ATTACHMENT A

EXISTING TECHNICAL SPECIFICATIONS AND BASES  
UNIT 3

**ATTACHMENT B**

PROPOSED TECHNICAL SPECIFICATIONS AND BASES  
UNIT 3

FIGURE 3.4-6

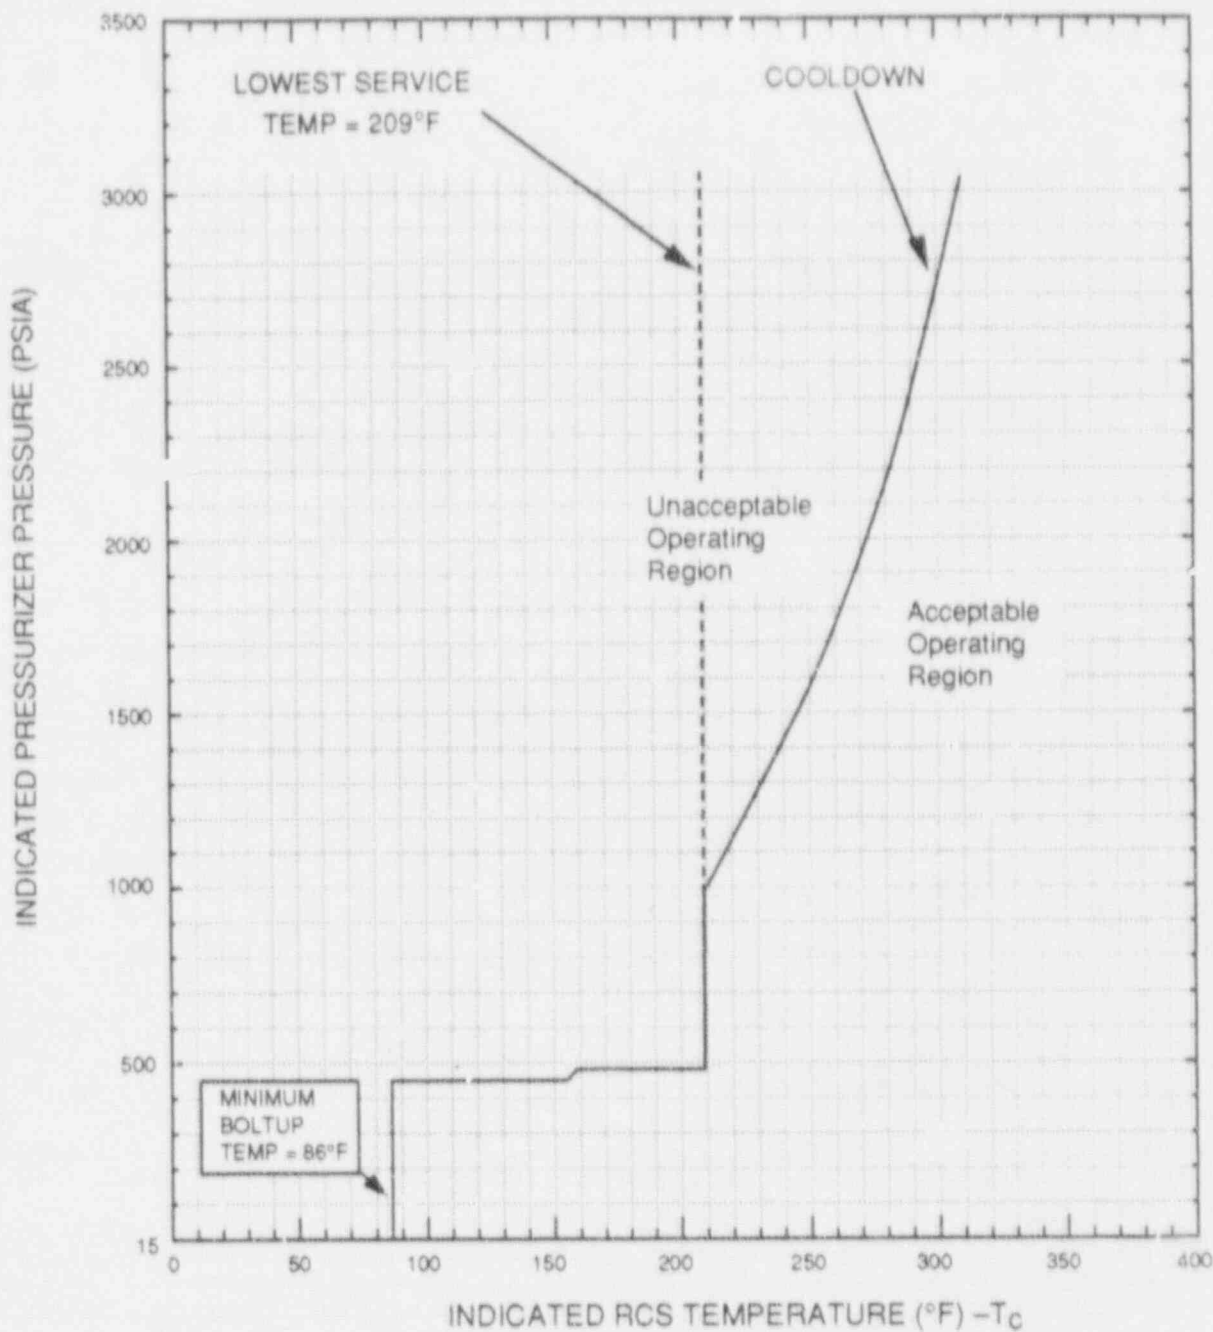
3.4-6 SONGS 3 COOLDOWN RCS PRESSURE/TEMPERATURE LIMITATIONS UNTIL 20 EFY-REMOTE SHUTDOWN OPERATION.....	3/4 4-31b   sup2
3.4-7 SONGS 3 RCS PRESSURE/TEMPERATURE LIMITS MAXIMUM ALLOWABLE COOLDOWN RATES (UNTIL 20 EFY)-REMOTE SHUTDOWN OPERATION.....	3/4 4-31c   sup2

SONGS 3 COOLDOWN RCS PRESSURE/TEMPERATURE  
LIMITATIONS UNTIL 20 EFY  
Remote Shutdown Operation

The heatup and cooldown limit curves for normal operation (Figures 3.4-2 and 3.4-34) and the cooldown limit curve for remote shutdown operation (Figure 3.4-6) are composite curves which were prepared by determining the most conservative case, with either the inside or outside wall controlling, for any heatup rate of up to 60°F/hr or cooldown rate of up to 100°F/hr. The limit curves for Remote Shutdown operation are determined using the Total Loop Uncertainties (TLUs) for temperature and pressure for the Remote Shutdown Panel instruments in which the pressure TLUs are higher than those for the Control Room shutdown instruments. The heatup and cooldown curves were prepared based upon the most limiting value of the predicted adjusted reference temperature at the end of the service period indicated on Figures 3.4-2 and 3.4-3, and they include adjustments for instrument uncertainties, and static and dynamic heads.

FIGURE 3.4-7

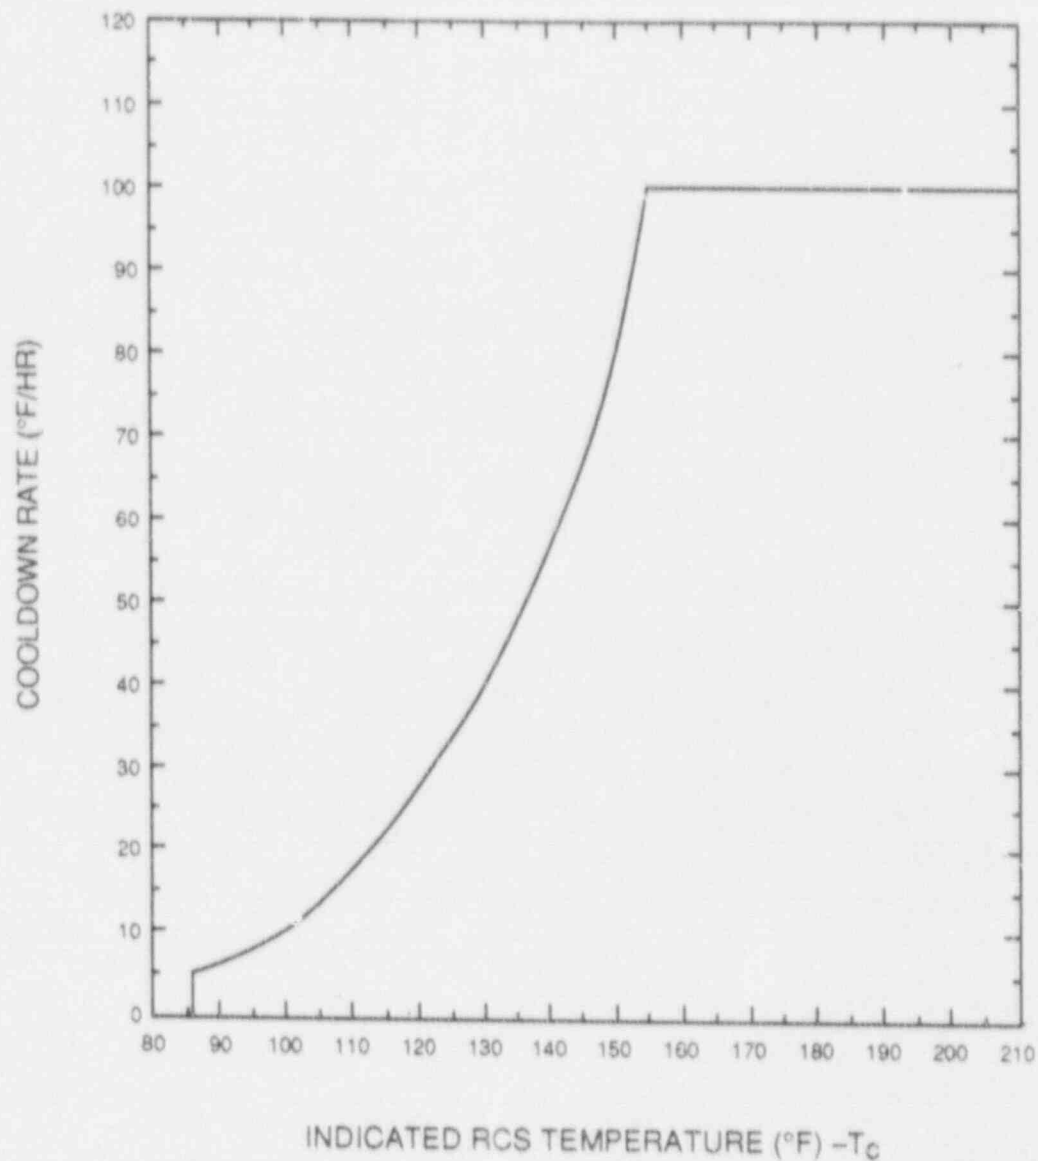
NOTE: A MAXIMUM COOLDOWN RATE OF 100°F/HR IS ALLOWED  
AT ANY TEMPERATURE ABOVE 155°F

SONGS 3 RCS PRESSURE/TEMPERATURE LIMITS  
MAXIMUM ALLOWABLE COOLDOWN RATES (UNTIL 20 EFPY)  
Remote Shutdown Operation
